STAFF RECOMMENDATION

NCPC File No. 5907

MARTIN LUTHER KING, JR. MEMORIAL—REVISED CONCEPT
TIDAL BASIN, WEST POTOMAC PARK
Washington, D.C.

November 30, 2006

REVISED ENTRY PLAZA EDGE AT THE EXTERIOR OF THE MOUNTIAN OF DESPAIR

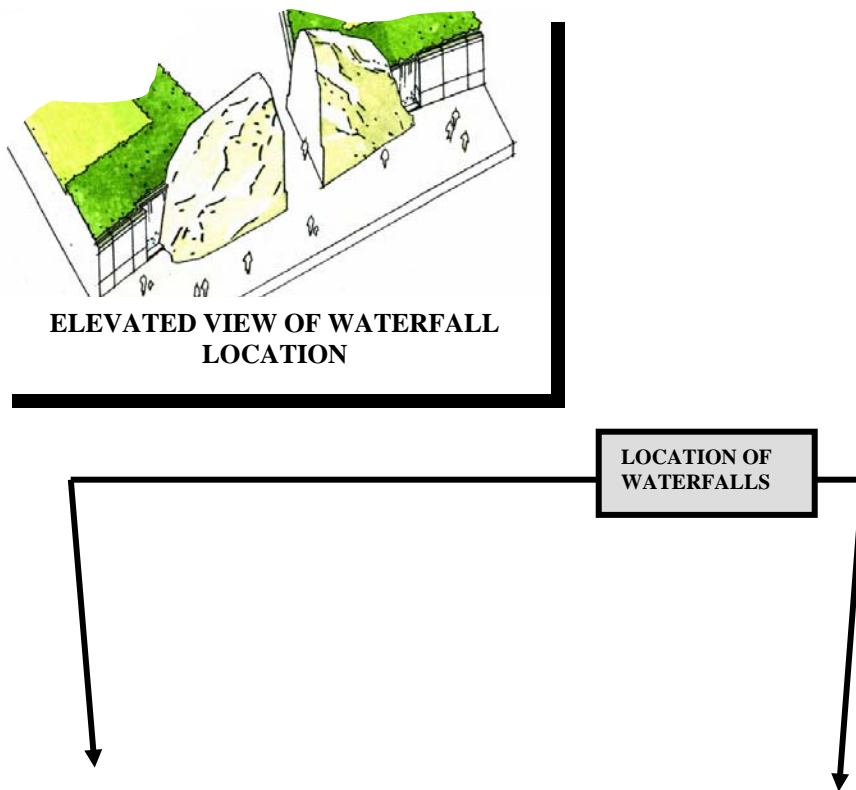
An additional change occurs at the front of the portal entry facing the intersection of Independence Avenue and West Basin Drive. The revision now provides a more naturalistic and landscaped edge to the Mountain of Despair, by eliminating the retaining walls that were originally featured at the front of the portal area along the entry plaza. This revision is demonstrated in the perspective highlighting that area on page 5.

INTERIOR PERSPECTIVE SKETCH VIEW OF THE RE-INTRODUCED WATERFALLS FLANKING THE MOUNTAIN OF DESPAIR

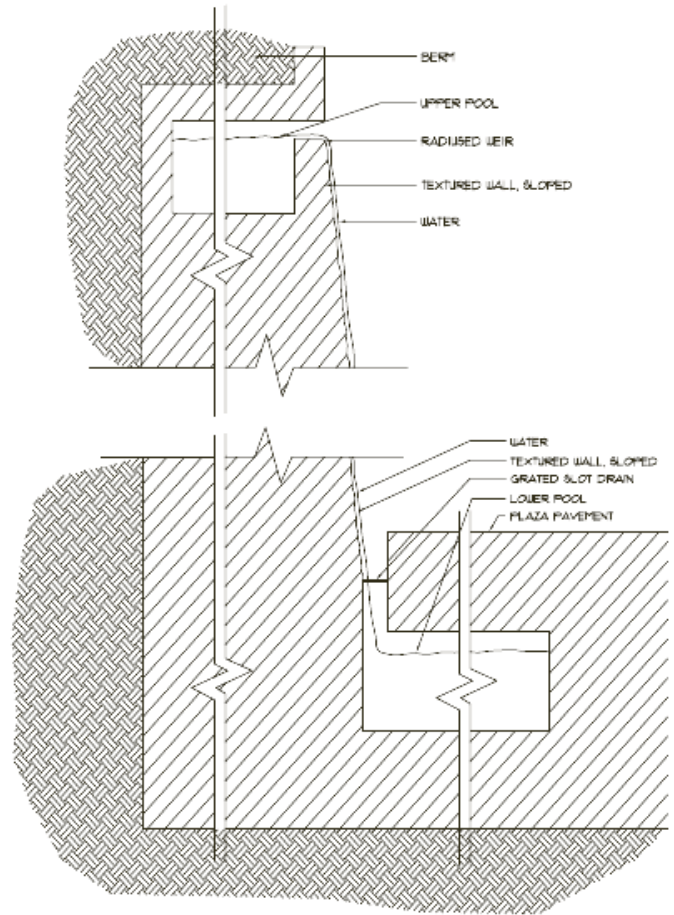
The Mountain of Despair is a large stone approximately 30 feet high that forms a portal for the main entrance to the memorial. This stone is pierced and opened to provide a 12-foot wide entry threshold and now exhibits a simple one-level cascading waterfalls flanking the stones at the interior side of the memorial. The revision to re-introduce water to the portal area is indicated in the following graphic on page 4 and in the subsequent graphics that provide detail on the concept.

Staff is very receptive to the idea of the re-introduction of water as a transitional element between the portal of natural stone and the finished inscribed wall with Dr. King’s orations. The proposed form of the waterfall and its simple single-height cascade reinforces the simplicity of the other memorial forms, and also relates to the rising wall. Most importantly, the spatial presence, and impact of the strong vertical form of the main interior wall is now transitioned by a fluid and lighter element, which provides the contrast but harmonizing relationship of water and stone within the context of the interior finished wall. The design, with its simpler and restrained water form does not compete nor diminish the *Mountain of Despair*. And while staff enthusiastically supports the concept design refinements, staff is concerned about the interface of the fountain with the larger stones at the portal. Whether this touch-point is achieved by an

altered physical connection or requires a complete break-away from the larger stones of the portal appears to be the dilemma that the applicant has not yet resolved. Staff clearly recognizes the design refinement of the fountain can be pursued and submitted at the preliminary project design submission stage.

At its October 19, 2006 meeting the Commission of Fine Arts reviewed the revised concept design for the memorial featuring the waterfalls. The Commission did not approve the proposed revision to add the two water features flanking the *Mountain of Despair*. The Commission requested that the design team continue its study of the crucial connection of the water, the Mountain, and the inscribed interior wall, recommending that several alternates be developed for their consideration. It was recommended one of the alternatives should investigate completely separating the wall from the *Mountain of Despair*.
